# Errata to MPC8323E PowerQUICC II Pro Integrated Host Processor Family Reference Manual, Rev. 2

This errata describes corrections to the *MPC8323E PowerQUICC II Pro Integrated Host Processor Family Reference Manual*, Revision 2. For convenience, the section number and page number of the errata item in the reference manual are provided.

**Figure 5-15. DDR Control Driver Register (DDRCDR)**

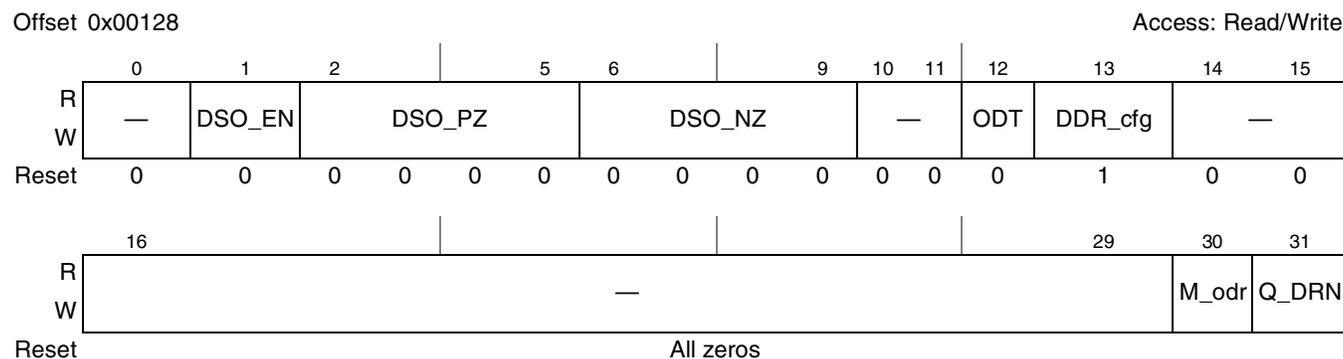
5.3.2.6, 5-22 Add Section 5.3.2.6, “DDR Control Driver Register (DDRCDR),” as follows:

The DDR control driver register (DDRCDR) contains bits that allow control over the driver of the DDR SDRAM controller.

DDRCDR is shown in [Figure 5-15](#).

Figure 10-29. External Termination of GPCM Access

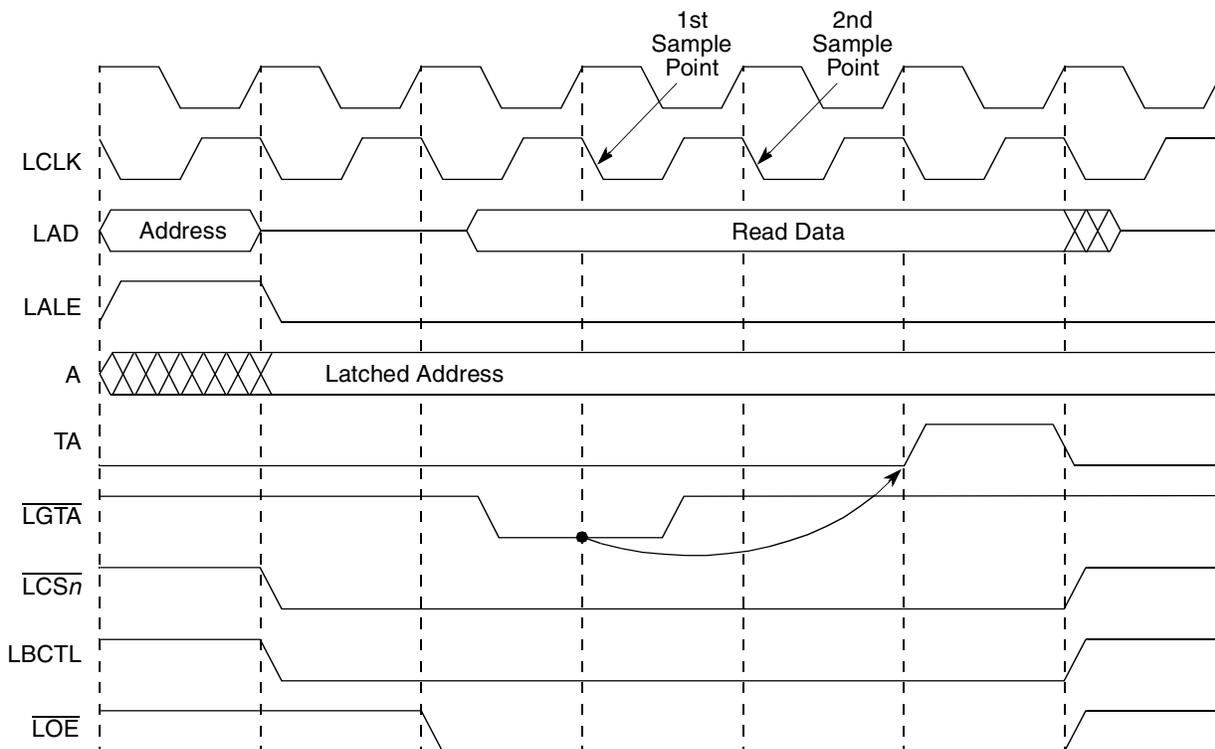
- 10.4.2.3, 10-41    Update Figure 10-29, “External Termination of GPCM Access,” as follows:
